**TOWN OF TRUMBULL
REQUEST FOR PROPOSAL**

WHITNEY AVENUE AT ROUTE 111 INTERSECTION IMPROVEMENTS

**RFP: #6326
DUE: January 17, 2019 @ 2:00 PM**

Addendum #1 Dated January 4, 2019

Project No. & Name STANDARDS
 Subject SIDEWALKS & CURBING
 Made by FMS Date 8/13/14
 Chk. by FMS Date 8/13/14
 SW-1 Sheet No. 1 of 2

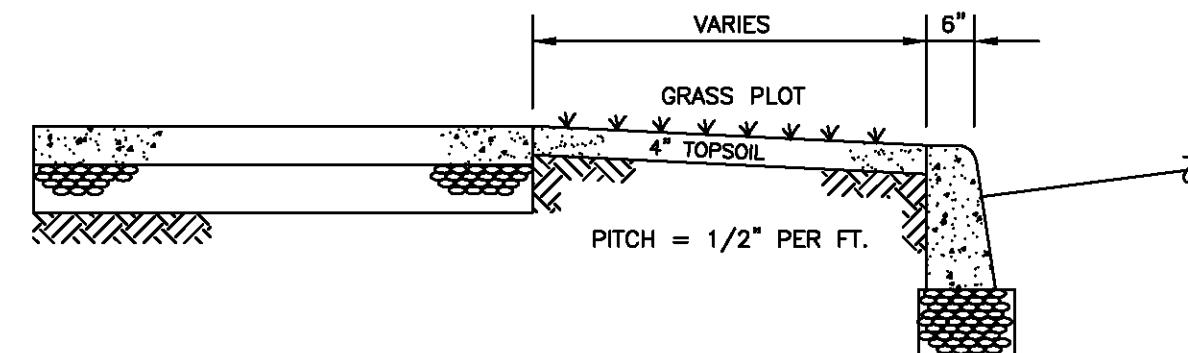
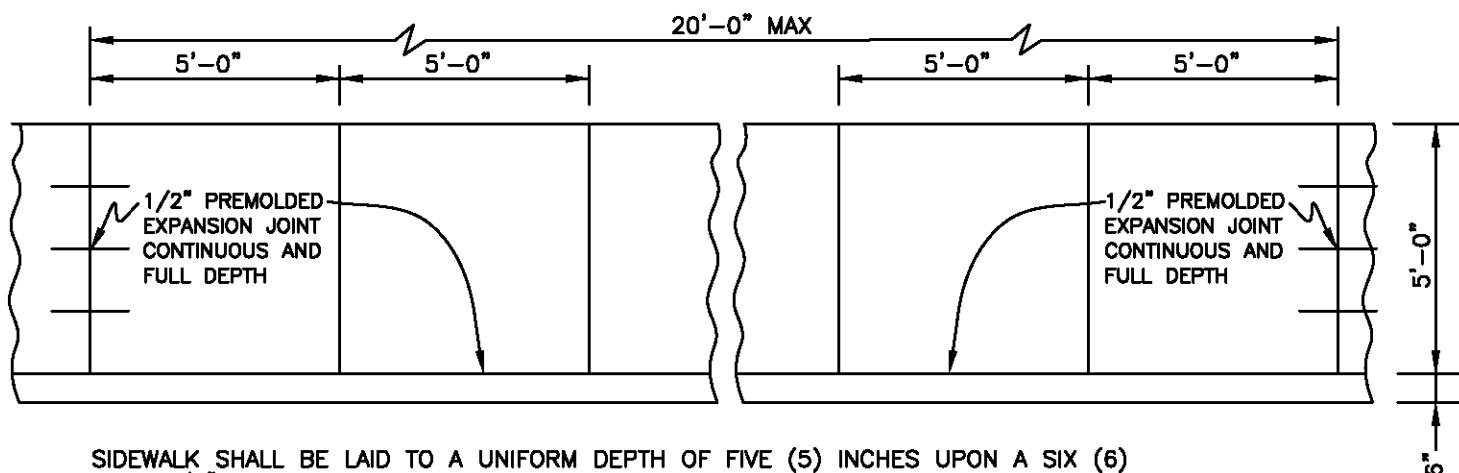
The details on the attached sheets, SW-1 and SW-2 Sidewalks and Curbing, shall supersede any similar details on the drawings.
